UNITED STATES PATENT AND TRADEMARK OFFICE

APPLICATION NO.	FILING DATE	FIRST NAMED INVENTOR	ATTORNEY DOCKET NO.	CONFIRMATION NO.
10/797,571	03/11/2004	Akihiro Moto	033035M143	4805

Office Action Summary

DETAILED ACTION

Figures 11 and 12 by Uchida ('278).

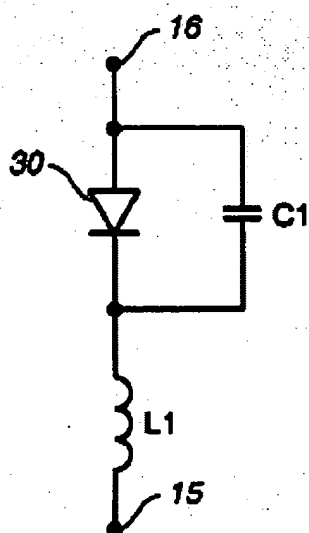
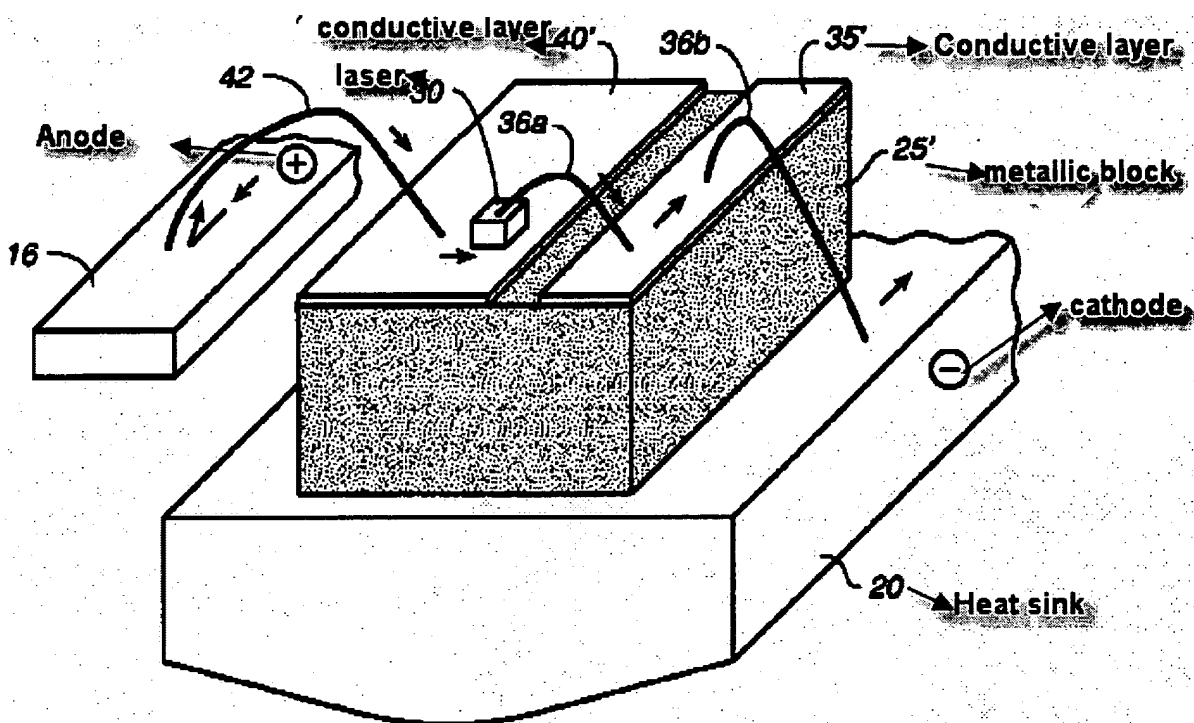
Claims 1, 6 are rejected under 35 U.S.C. 102(b) as being anticipated by Uchida (6,301,278).

Regarding claim 1, Uchida discloses in Figure 11 and 12 a light-transmitting module, comprising: a stack of a metallic block (see Fig. 11, Character 25', Column 2, Lines 20 – 21), an insulating heat sink (21see Fig. 11, Character 20) mounted on said

metallic block and an electrically conductive layer (see Fig. 11, Characters 35' and 40') formed on said insulating heat sink, said stack forming a parallel-plate capacitor; and a laser diode (see Fig. 11, Character 30) having an anode and a cathode, said laser diode being mounted on said conductive layer such that said anode faces and is in contact with said conductive layer (Column 1, Lines 31 – 34, Column 2, Lines 11 – 41 and Column 3, Lines 1 – 10) .

Regarding claim 6, Uchida discloses in Figure 11 and 12 a light-transmitting module, comprising: a stack of an electrically conductive heat sink (see Fig. 11, Character 25', Column 2, Lines 20 – 21), an insulating layer provided on said heat sink (21see Fig. 11, Character 20) and an electrically conductive layer (see Fig. 11, Characters 35' and 40'), said stack forming a parallel-plate capacitor; and a laser diode (see Fig. 11, Character 30) mounted having an anode and a cathode, said laser diode being mounted on said conductive layer such that said anode faces and is in contact with said conductive layer (Column 1, Lines 31 – 34, Column 2, Lines 11 – 41 and Column 3, Lines 1 – 10)
